UNITED STATES PATENT AND TRADEMARK OFFICE

10/539,654

Office Action Summary

DETAILED ACTION

Kalb *et al.* also shows the known relationship between the load angle and torque on a synchronous motor. See, for example, figure 4:

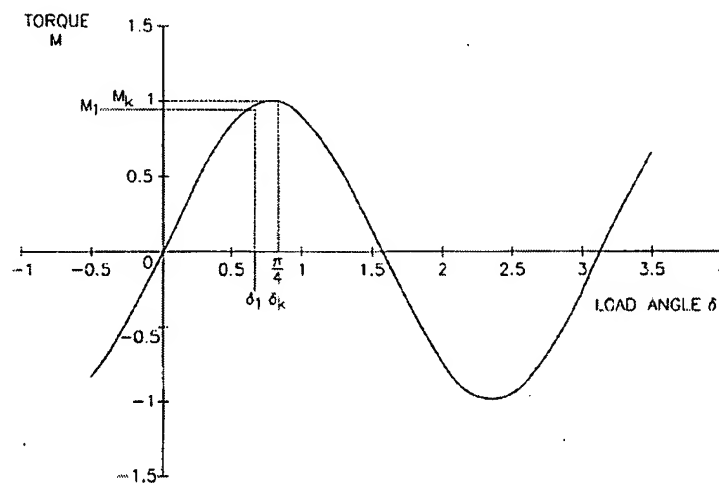
It would have been obvious to one of ordinary skill in the art at the time of the invention to modify the teachings of Kunz with the teachings of Van Cleve *et al.*, the admitted prior art, and Kalb *et al.* in order to indirectly determine the flow rate of the pump by acquiring the phase shift of the motor between the voltage applied to the terminals of the motor and the counter-
